APPLICATION NO.	FILING DATE	FIRST NAMED INVENTOR	ATTORNEY DOCKET NO.	CONFIRMATION NO.
10/795,878	03/08/2004	Chi-Ming Huang	250913-1150	2105

Office Action Summary	Application No. 10/795,878	Applicant(s) HUANG ET AL.	
	Examiner Jason Uhlenhake	Art Unit 2853

- 1) ☒ Responsive to communication(s) filed on 26 October 2006.
- 2a) ☒ This action is **FINAL**. 2b) ☐ This action is non-final.
- 3) ☐ Since this application is in condition for allowance except for formal matters, prosecution as to the merits is closed in accordance with the practice under *Ex parte Quayle*, 1935 C.D. 11, 453 O.G. 213.

FIG. 9

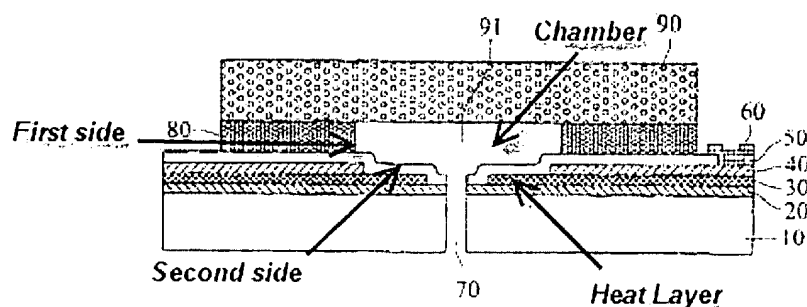
- ***regarding claim 1***, providing a substrate and a porous material (Figure 9; Column 2, Lines 12 – 31; Column 3, Lines 47 - 53)
- forming a heating layer on the substrate; forming a conductive layer on the substrate, wherein the conductive layer conducts a current to the heating layer, and a

- forming a chamber (91) for storing liquid above the heating area, wherein the chamber includes a first side and a second side, the first side faces the heating area, the second side is connected to the first side, and the chamber is formed with an exit, from which the liquid is dispensed, on the second side; (Figure 9)

- placing the porous material (90) on the chamber (91) so that the liquid flows into the chamber therethrough (Figure 9; Column 2, Lines 29 – 31)

- **regarding claim 11**, a substrate; heating layer disposed on the substrate to dispense liquid; conductive layer disposed on the substrate to conduct a current to the heating layer, wherein a heating area is defined by the conductive layer and the heating layer (Figure 9; Column 2, Lines 14 – 31; Column 3, Lines 21 – 35)

first side, and the chamber is formed with an exit, from which the liquid is dispensed, on the second side (Figure 9)

- porous material disposed on the substrate, wherein the liquid flows into the chamber through the porous material (Figure 9; Column 2, Lines 29 – 31)

- forming an adhesive layer (80) on the conductive layer (40) (Figure 9)

- placing the porous material on the adhesive layer to form a chamber (91) for storing liquid, wherein the liquid flows into the chamber through the porous material, the chamber includes a first side and a second side, the first side faces the heating area, the second side is connected to the first side, and the chamber is formed with an exit, from which the liquid is dispensed, on the second side; (Figure 9)

- **regarding claim 18**, wherein the porous material (90) includes a groove by cutting (no structural limitation for an apparatus claim, therefore it is not given

patentable weight) to form the chamber before placing on the adhesive layer (80)

- an adhesive layer (80) on the conductive layer (40) (Figure 9)

- porous material, disposed on the substrate, including a chamber (91), wherein the liquid flows into the chamber through the porous material, the chamber includes a first side and a second side, the first side faces the heating area, the second side is connected to the first side (Figure 9)

Applicant's arguments filed 10/26/2006 have been fully considered but they are not persuasive. Please see the above rejections regarding Chen et al. Applicant argues that the structure of Chen et al does not disclose that the first side is overlapped with the heating area. However, the first side is overlapping the heating area as claimed (Figure 9). The heating area is defined by the conductive layer (40) and the heating layer (30) as disclosed by the specification and currently amended claim. The current claim does not state that the first side completely overlaps the heating area and does not clearly define the structure of the heating area.

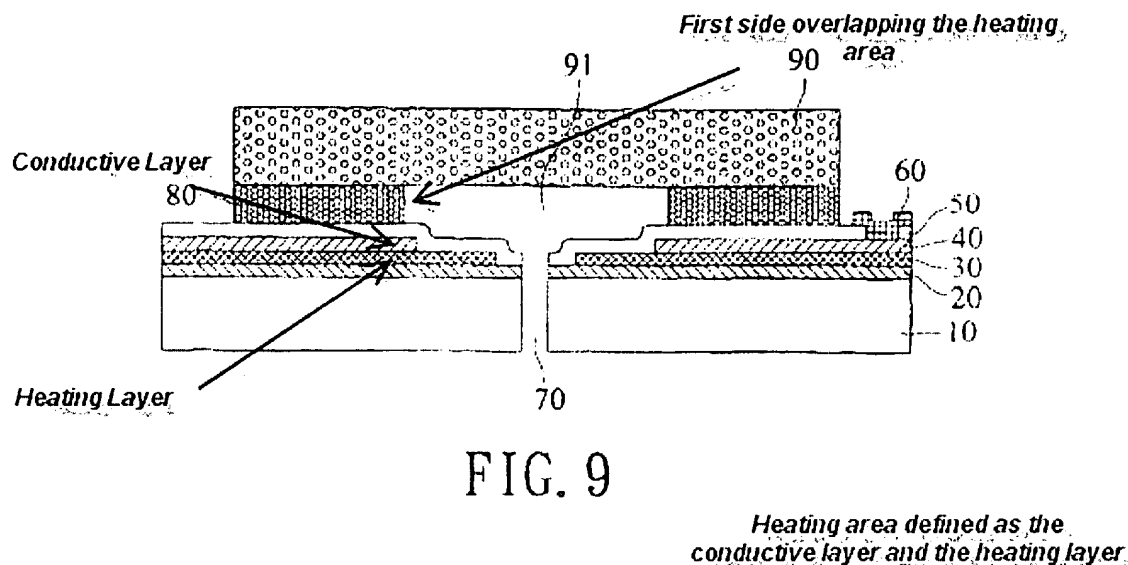
- **regarding claim 13**, wherein the chamber is metal (Paragraph 0032), for the purpose of having a high thermal conductivity and dissipate heat from the heater
